MONITORING YEAR 4 ANNUAL REPORT

SHAKE RAG MITIGATION SITE

RE: Draft MY4 Report Review
Shake Rag Mitigation Site, Madison County
French Broad River Basin: 06010105
DMS Project ID No. 100018
DEQ Contract #7190

Wildlands Engineering, Inc. (WEI) has reviewed the Division of Mitigation Services (DMS) comments from the Draft Monitoring Year (MY) 4 report for the Shake Rag Mitigation Site. DMS' comments are noted below in **bold**. Wildlands' responses to those comments are noted in *italics*.

Figure 3.1 Monitoring Plan View Map
Shake Rag Mitigation Site
DMS Project No. 100018
Monitoring Year 4 - 2023

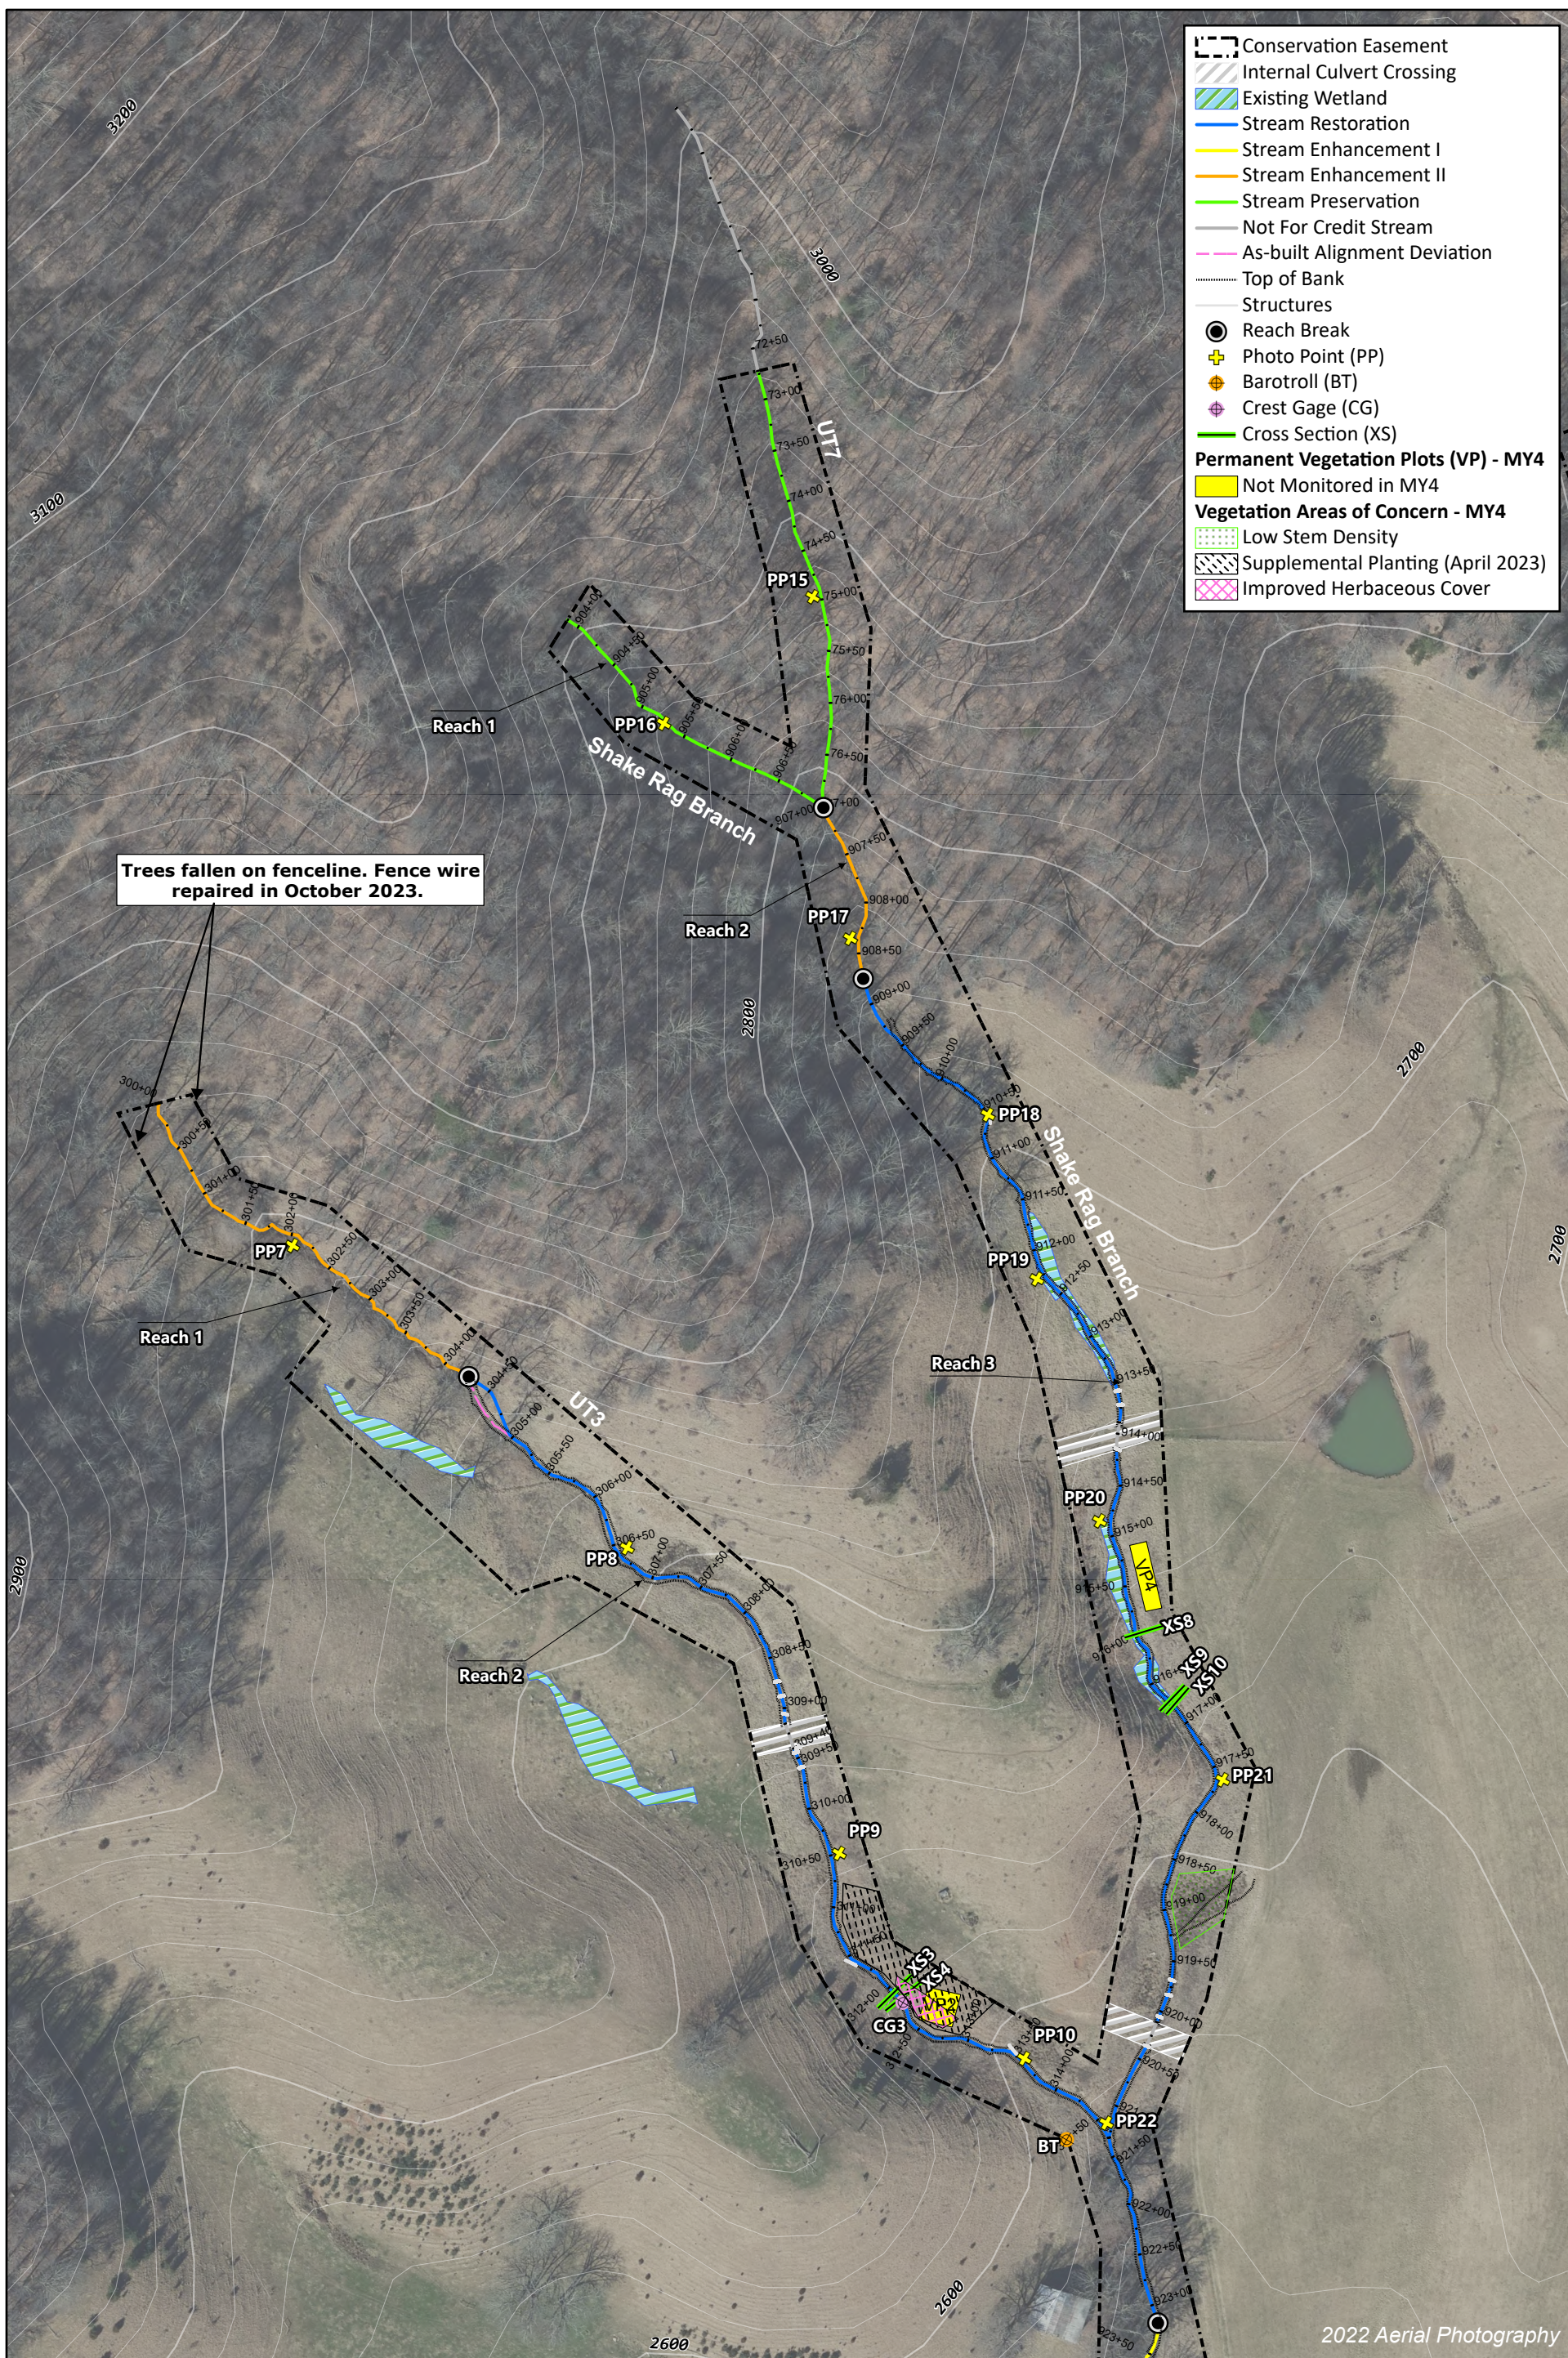
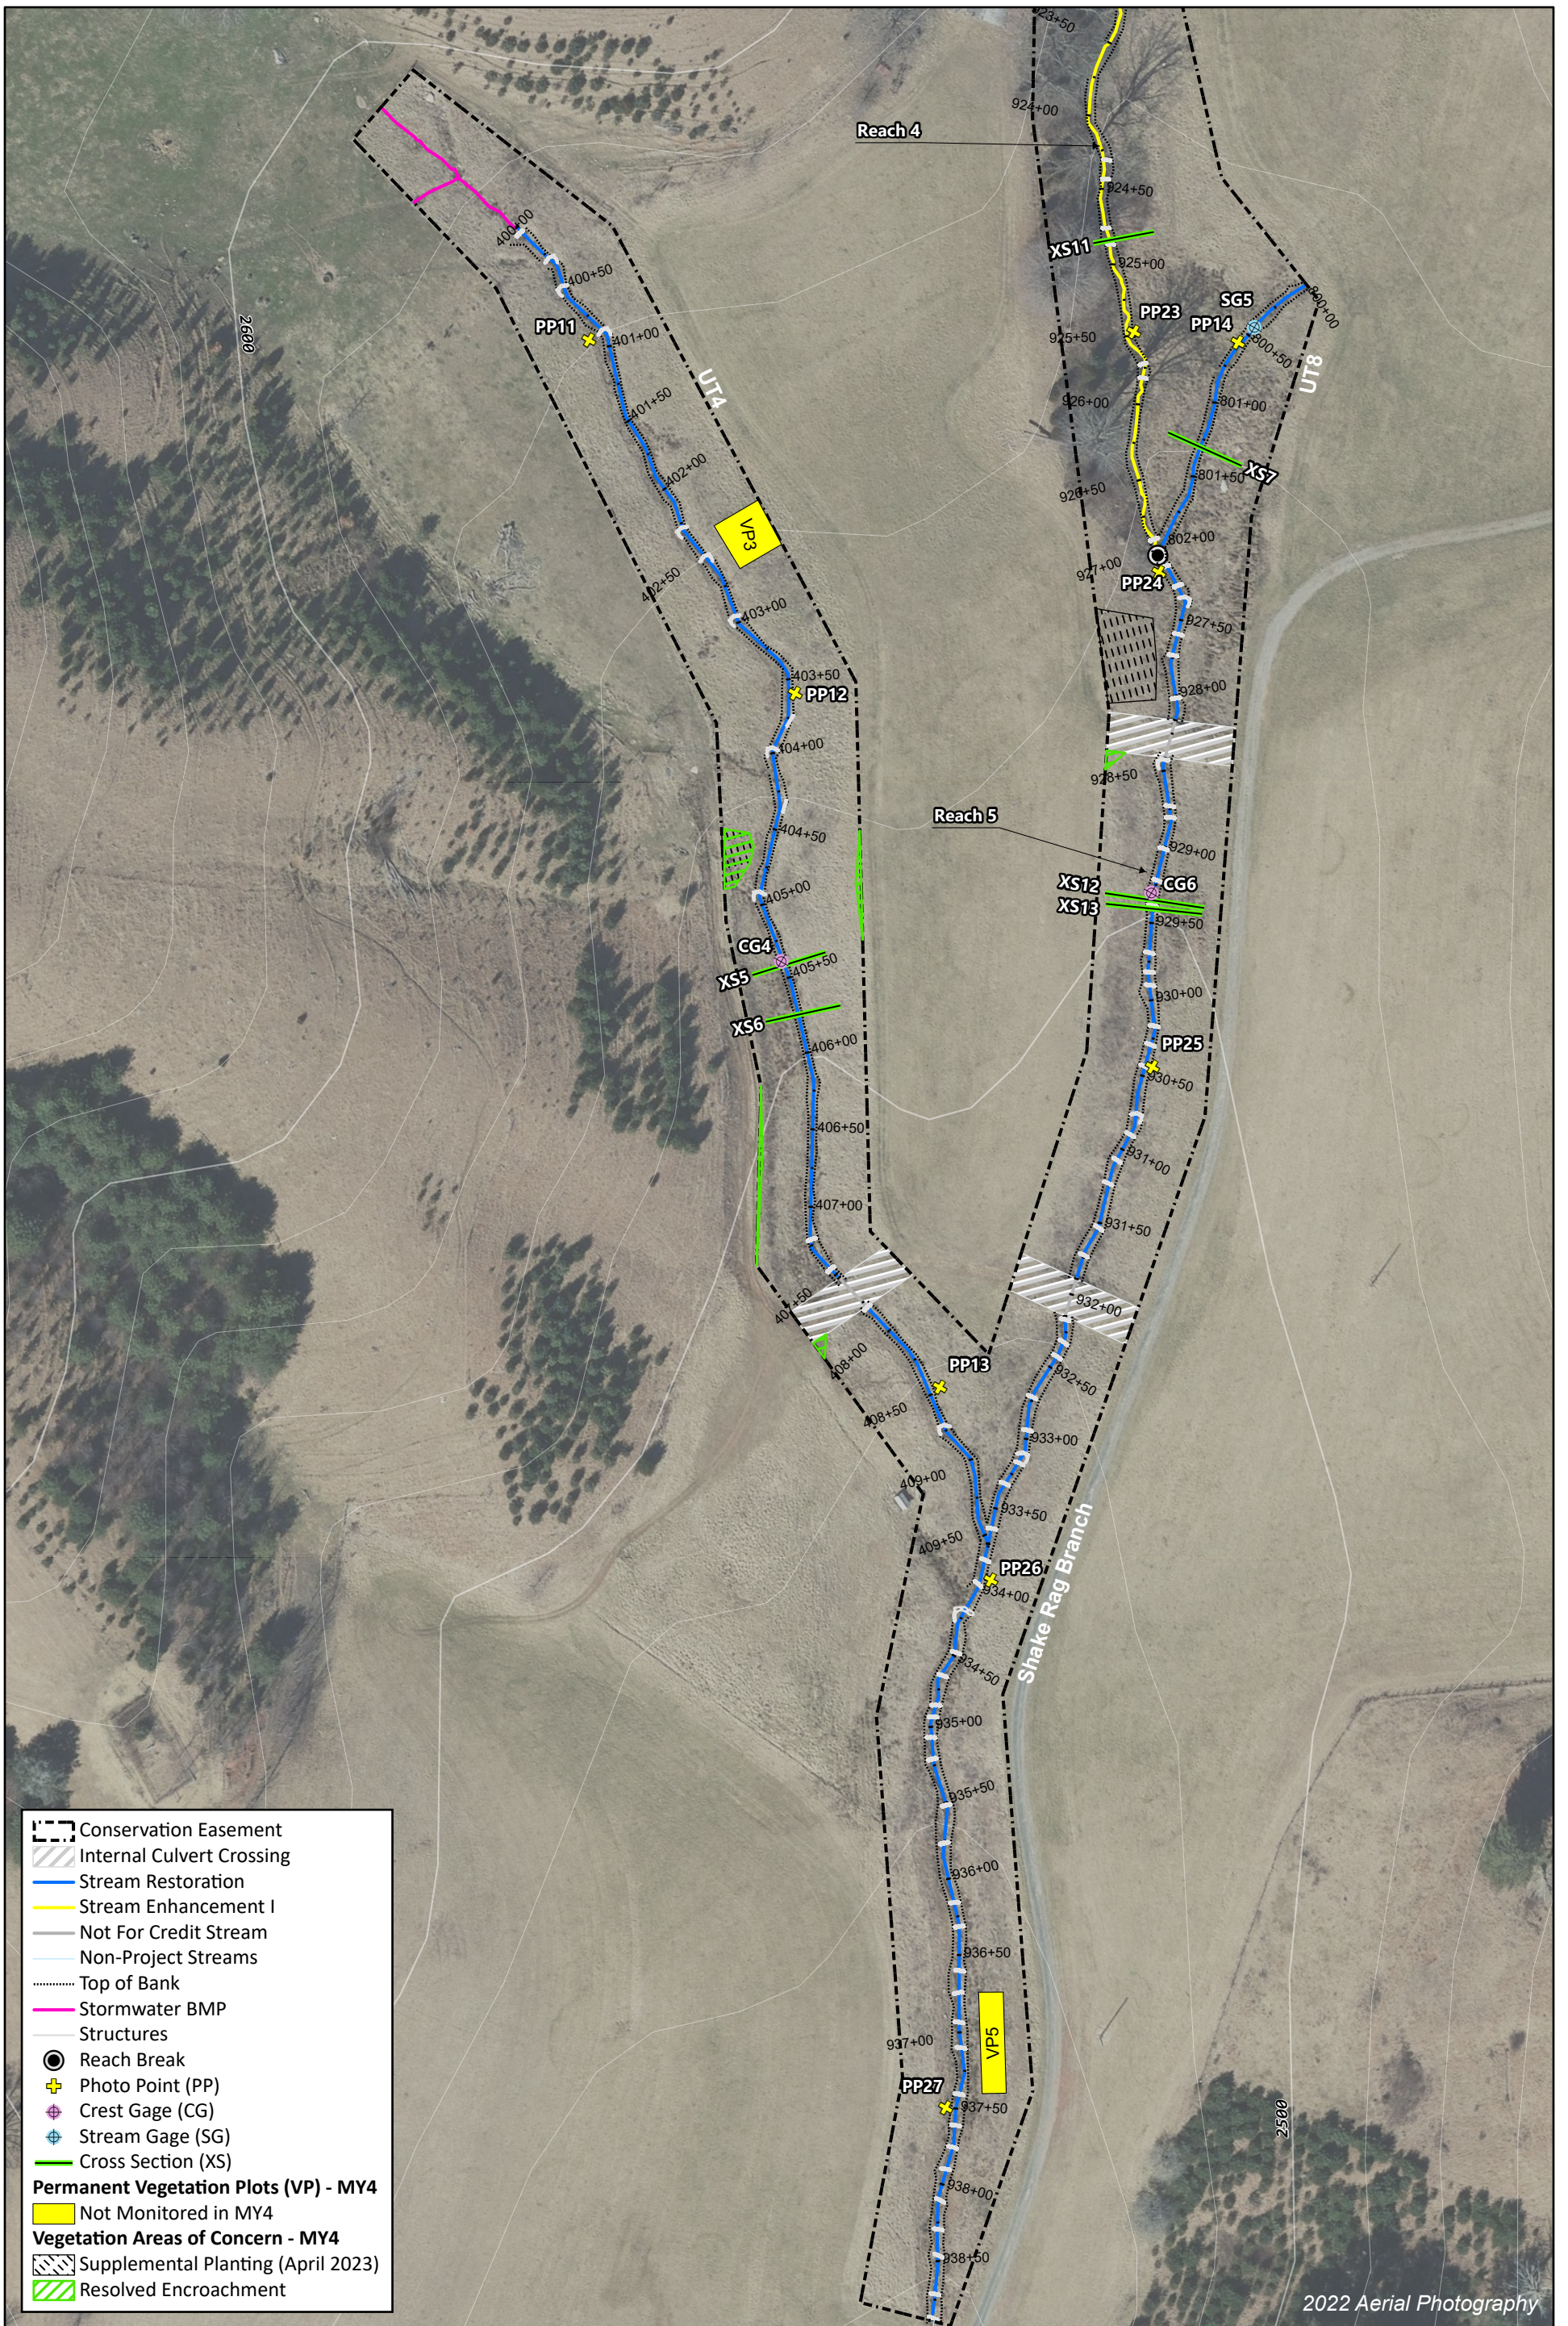
Does WEI have any before/after pics of the UT3 side slope areas of poor growth that received reseeded and compost tea in MY4? Please add this area to the MY4 CCPV.

DMS appreciates the Conservation Easement Boundary Issue Table that was included in the MY4 report. Please include the resolved conservation easement boundary issues on the MY4 CCPV.

Wildlands' response: Before/after photos of the UT3 side slope areas have been added to a photolog in Appendix 2. This area of improved herbaceous cover has been added to the MY4 CCPV (Figure 3.2).

Wildlands' response: The resolved conservation easement boundary issues have been added to the MY4 CCPV figures.
